Service Information

Model: Saddle Finisher-G1 Ref. No.: FF-T01-W-000170-01

Date: June 28, 2002

Subject: Using a Different Stepping Motor (M2)

Figure 1

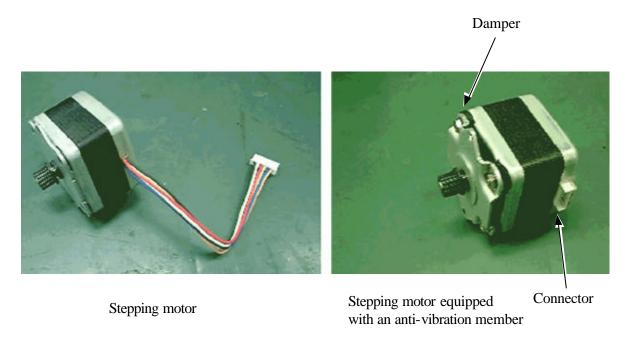
To accommodate the use of a stepping motor (M2) equipped with an anti-vibration member, the following changes have been made:

- 1. The shape of the positioning hole in the bracket has been relocated to permit the anti-vibration member.
- 2. The stepping paddle motor cable has been made longer to make up for the absence of a lead wire in the new motor.

When replacing the existing motor with an M2 motor equipped with an anti-vibration member, be sure to replace the following 3 items at the same time: stepping motor, stepping paddle motor cable, bracket.
